6673A-09

S E R V I C E N O T E

6673A - DC POWER SUPPLY, 0-35 V, 0-60 A, 2100 W. GPIB
CONTROLLED

The four filter capacitors circuit reference (C416-C419) on the A4 AC input board starts leaking electrolyte

Situation:

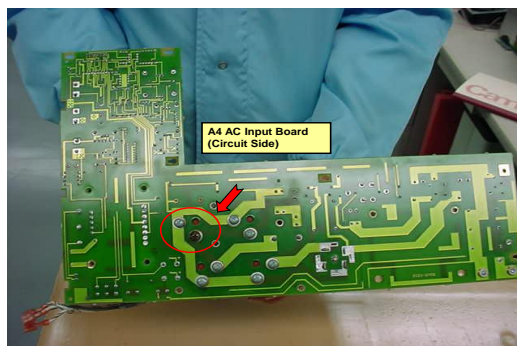
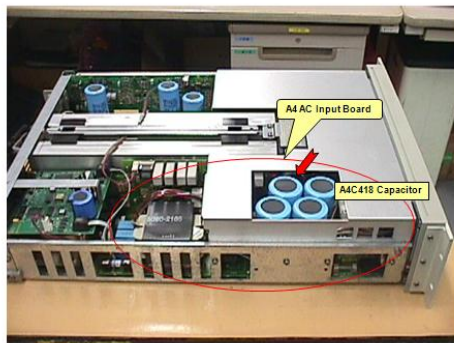
The four filter capacitors circuit reference (C416-C419) on the A4 AC input board starts leaking electrolyte - not through the pressure valve in the bottom as one would expect but through one of the terminal screw bushings.”

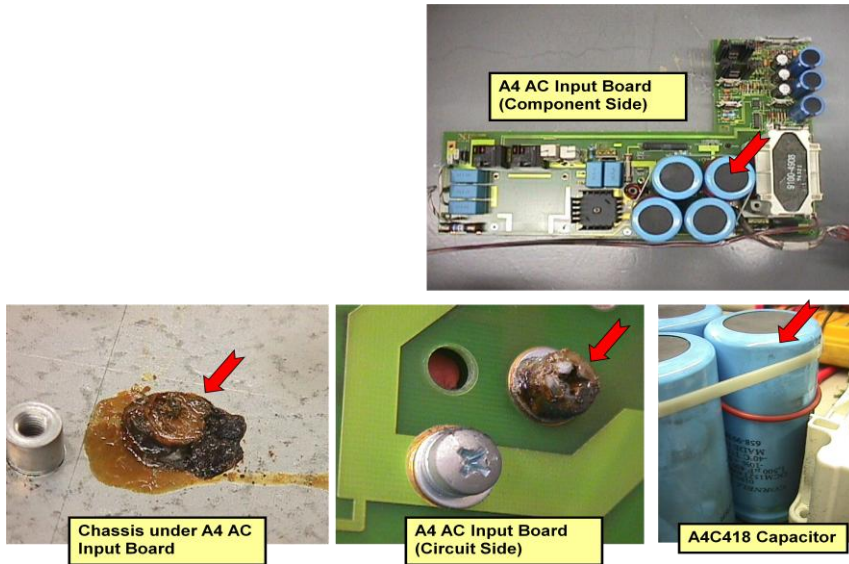
The screw P/N 2680-0217 length currently being used was not considered and the length was overlooked. The screw length is 0.375 inches long. We have found that the screw can be 0.055 inches too long and may bottom out causing the tapped hole in the header of the capacitor to become cracked or become broken.

When this happens the electrolyte will slowly leak out over time, and cause the defect described. This situation is even worse due to the capacitor is mounted with the header face down. If the capacitor was mounted header face up a cracked or broken header would not have caused this problem, the electrolyte could not leak out.

1. All affected models and tested assemblies WIP (Work In Process), FGI (Finished Goods Inventory) at SPO (Support Parts Organization) & AMC (Asian Manufacturing Center) has been inspected for capacitors with damaged headers due to the incorrect screw
2. When this repair is being done all of the hardware described above should be replaced (It is NOT recommended that any of the hardware be reused)
3. The following figures can be used when doing the repair.
4. Inspect the assembly as described below.
5. The last figure will aid in the reassembly of the hardware and the capacitors.
